In the matter of applications by Gisborne District Council for resource consents to modify a stopbank at Te Karaka

Statement of rebuttal evidence of Mark Hooker on behalf of Gisborne District Council

Flooding effects

Figure 1. Design event - change in velocity

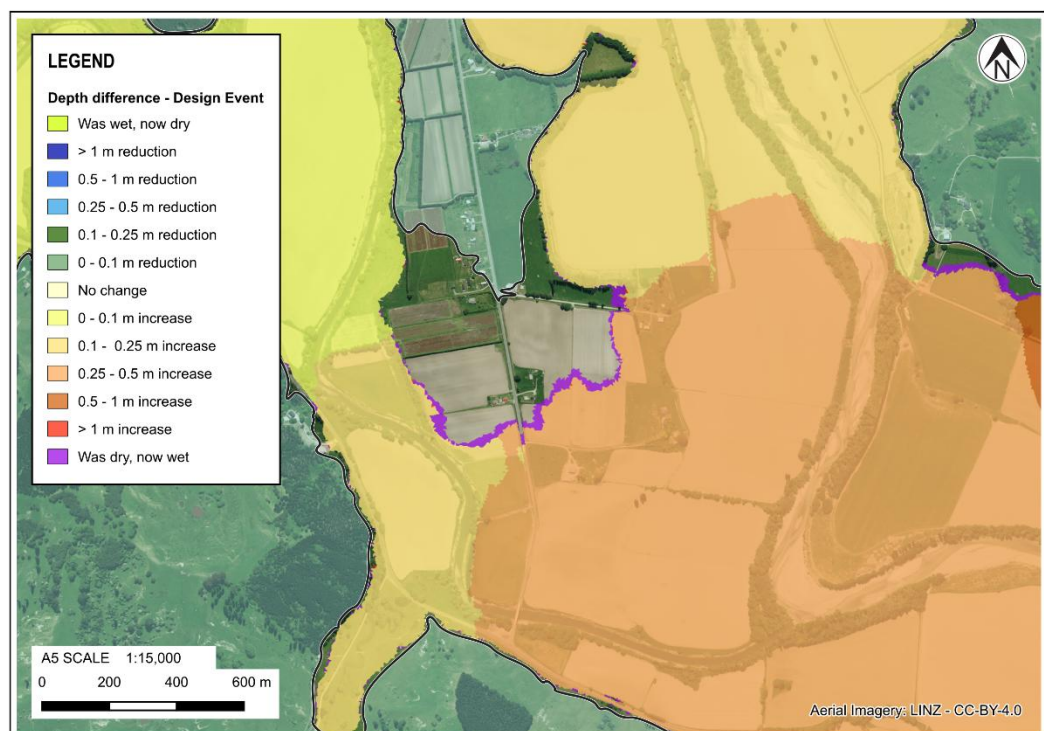
- 1.6 Mr Strong states in paragraph 60 of his evidence that maps showing velocity difference and depth difference across the Coates property would be useful. I

have included these below as Figure 1 and Figure 2, respectively. Most of the velocity difference map is blank because the change is less than 0.1 m/s and sits within the “no change” category on the legend.
